Columbus Park Redevelopment Project

Initial Study/Mitigated Negative Declaration

RESPONSES TO PUBLIC COMMENTS

May 4, 2023

FIGURE 2.7-2

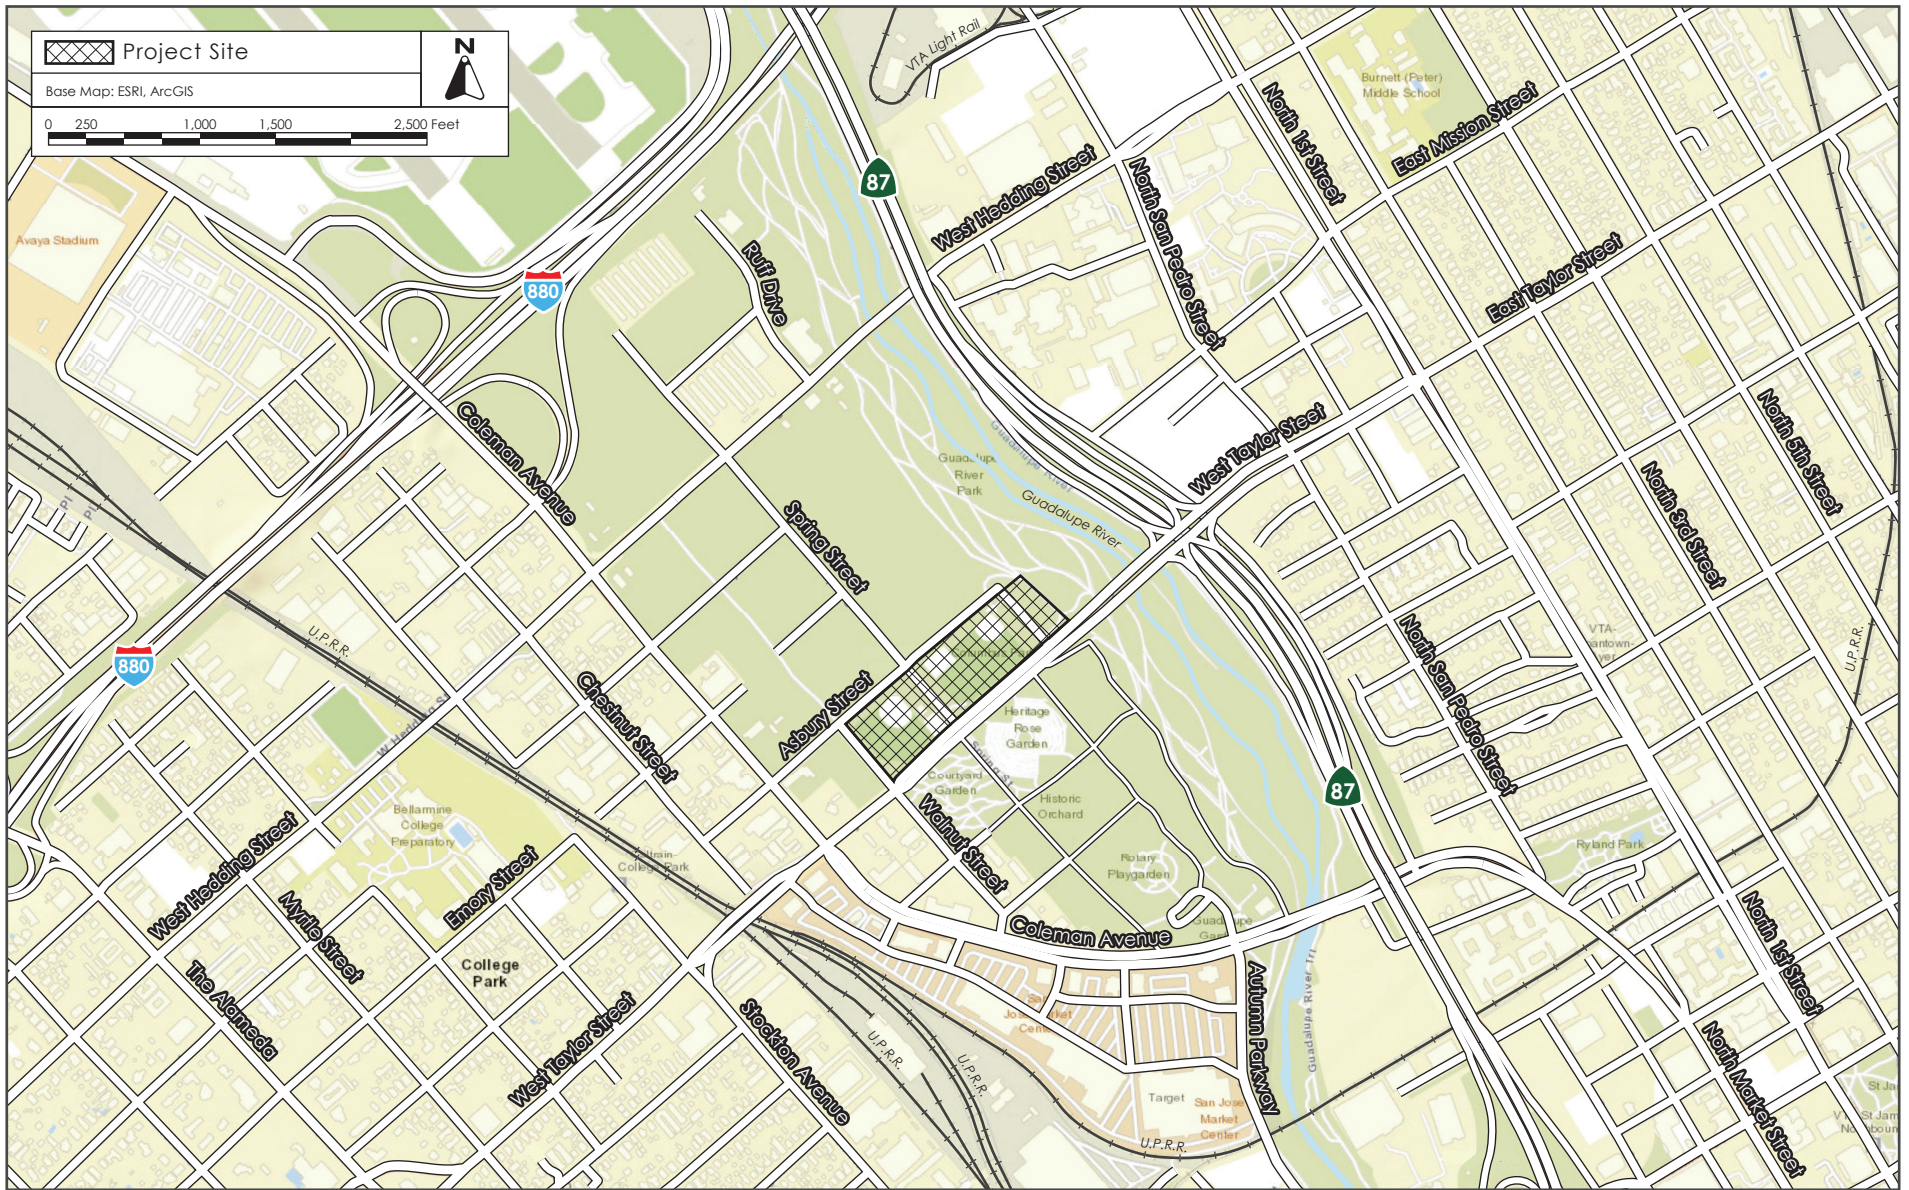
3. On page 4, Figure 2.7-2, the project area hatched on this figure does not appear to include the proposed parking lot (APN 259-07-114) nor match the project boundary shown on Figure 2.7-3 (Page 5) and Figure 3.2-1 (Page 7). Please revise the document for consistency.

3. **On page 4, Figure 2.7-2**, the project area hatched on this figure does not appear to include the proposed parking lot (APN 259-07-114) nor match the project boundary shown on Figure 2.7-3 (Page 5) and Figure 3.2-1 (Page 7). Please revise the document for consistency.

Response B.4: As discussed on page 44 of the IS/MND, the project site includes Columbus Park in San José and an undeveloped parcel located to the east of the park which contains a small gravel parking area and grass land. Figure 2.7-2 on page 4 of the IS/MND incorrectly outlined the project site as only the existing Columbus Park. Figure 2.7-2 on page 4 of the IS/MND has been revised to show the entire project site. This revision to Figure 2.7-2 does not change the analysis, adequacy, or the findings of the IS/MND.

Page 4 Figure 2.7-2 Regional Location Map: **REPLACE** with the following figure:
